**State of California  
The Resources Agency  
Department of Water Resources  
September 19, 2006**

**Addendum Number 2 to the Mitigated Negative  
Declaration for the Northern Pike Containment  
System at the Outlet of Lake Davis on Big Grizzly Creek**

Photo 1. View of west bank of Big Grizzly Creek downstream of Cipolletti weir. Rip-rap will be placed on stream banks and in the channel as shown by the orange arrows.

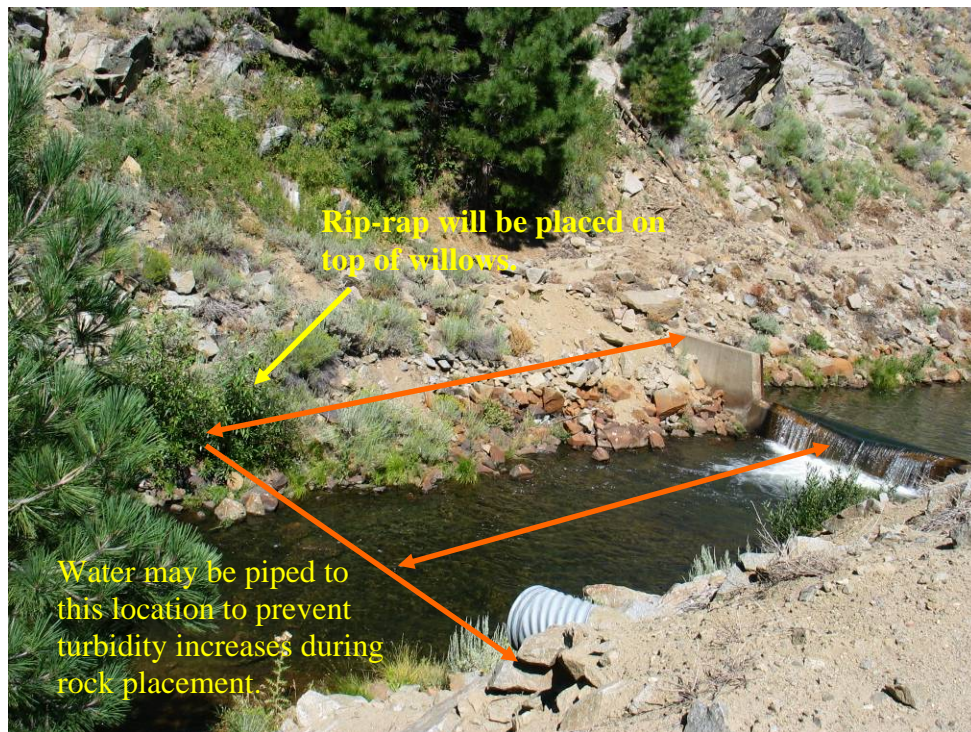
To protect against potential erosion, DWR will install rip-rap rock revetment on top of geotextile fabric as needed. The fabric and revetment may be placed downstream of the Cipolletti weir and extend forty feet downstream along the bottom and sides. Drawing 1 shows the maximum amount of rock that would be placed in the channel. Up to eighty cubic yards of rock will be placed on the banks and in the stream channel using a crane. Stream flow may be temporarily reduced and piped around the area of rock placement to minimize turbidity increases during rock placement. Rock will be placed on top of existing vegetation on the banks (Photo 1 and 2). The rock will be purchased from a nearby quarry, and will be 3 to 4 feet in size and cleaned prior to placement in creek.

Photo 3. View of area upstream of Cipolletti weir and future sump collection box.

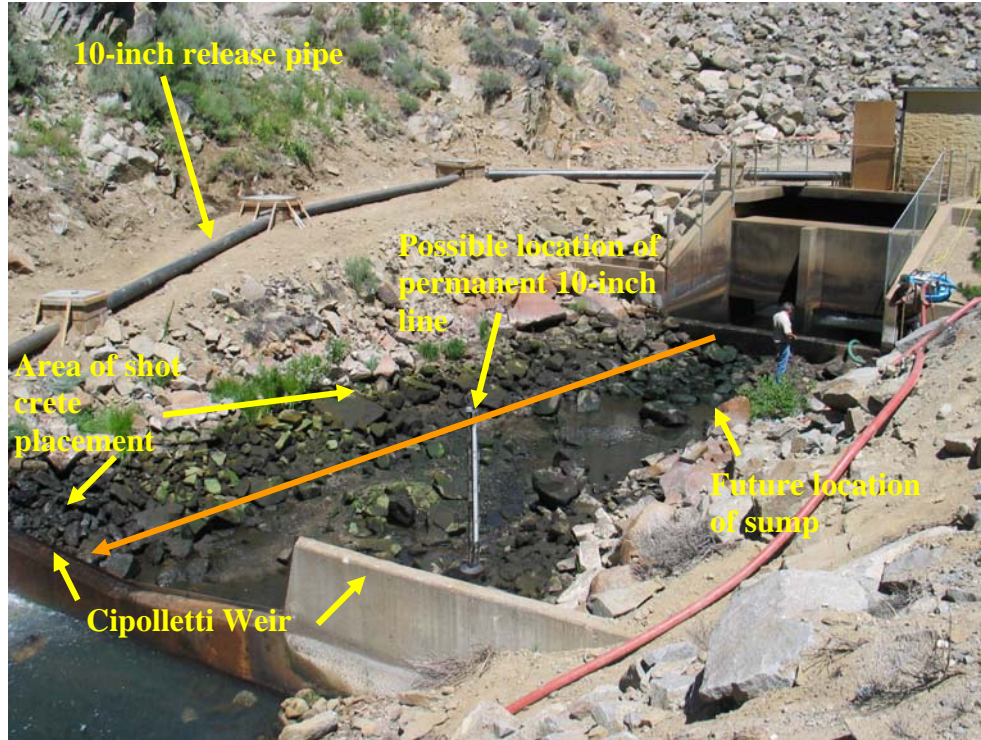
The west bank upstream of the Cipolletti weir is unstable and is undermining the thrust blocks which support the 10-inch steel, strainer bypass-pipe. A shot-crete layer, no more than two inches thick, will be placed over the west bank to stabilize the erodible material (Photo 3). The shot-crete layer will be localized to cover only the west bank upstream of the Cipolletti weir and below the 10-inch pipe.

The May 2006 Mitigated Negative Declaration and Initial Study does not describe the sump. The sump will be a concrete lined box about 2 feet high by 2 feet wide by 3 feet deep. It will be upstream of the Cipolletti weir between the concrete slab and left bank (Photo 3). The sump will be lined with concrete to prevent increases in downstream turbidity. The sump will be constructed in an area of the stilling basin that was once under the ordinary high water mark. No vegetation or portion of the bank will be disturbed during the construction of the concrete lined sump.
